EA11003EN-00493[0]

Subject: RE: CP4.1 assessment (R4 CR high pressure fuel pump from Bosch)

The following is a short summary of our telephone conversation on the unusual features of the disassembly audit of 06.19.2009

Fig. 1:
Pump no. 1 Data plate

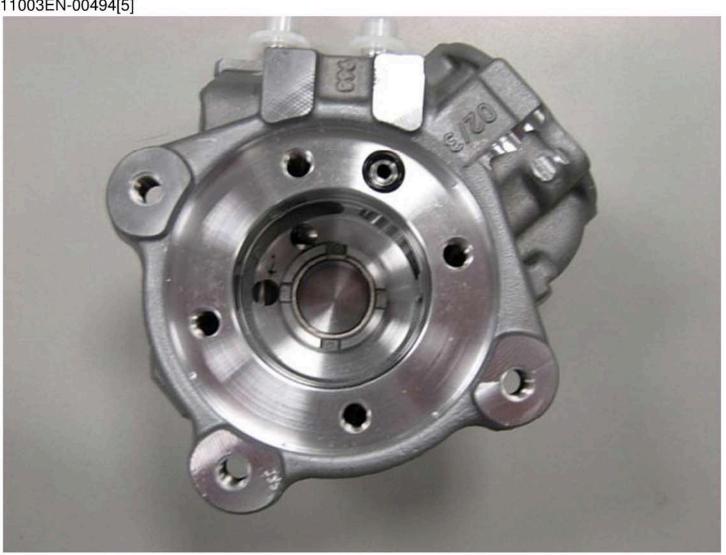
Fig. 1 ID plate - purely for information about pump data

Fig. 5: Pump no. 1 Roller, minor cracks on edge

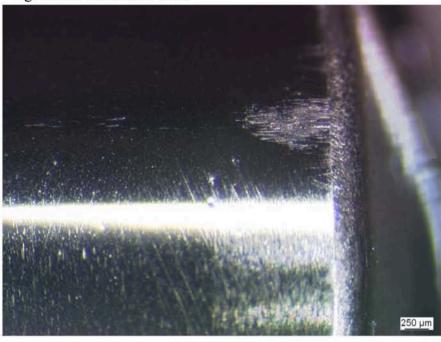
- Fig. 5: Minor scratches on the roller in axial direction approx. $350 \, \mu m$ familiar pattern, may be caused when the roller is manually inserted into the roller support. The roller can easily drop off in this area not functionally critical

Fig. 6: Pump no. 1 Space between compensating disk, contact bearing flange

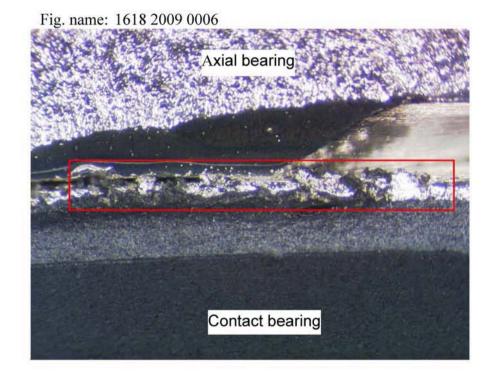
- Fig. 6: Intermediate space / faces of the spacer ring or bushing of the flange bearing surface structure shown is current state of production non-critical. Loose burr/shavings not permitted Area is cleaned in the housing's high-pressure washing system.

Fig. 7:

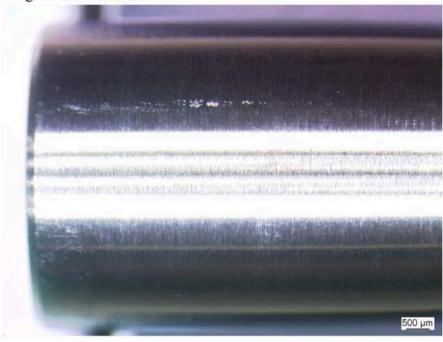
- Fig. 7: Very minor traces in axial direction on the running surface of the high-pressure piston not functionally critical may have occurred when joining or dismantling components

Fig. 8:

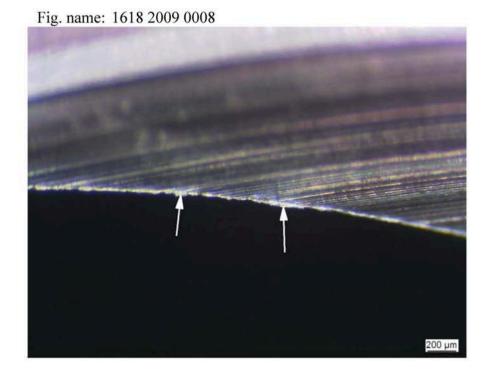
- Fig. 8: Very minor burr on the injection well of the roller support new subject. Details of the deburring process and preliminary processing will be discussed with you.

Sorry, I need to correct myself. Fig. 8 in the PDF relates to the tappet bore in the pump housing (see the photo captioned "Additional photo for Fig. 8", the bore of the tappet in which the pump moves) not the injection well of the roller support.

Fig. 10:

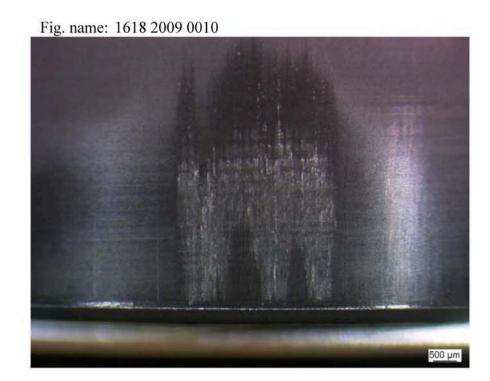
- Fig. 10: Run-in marks on the mantle surface of the tappet body normal run-in pattern, non-critical
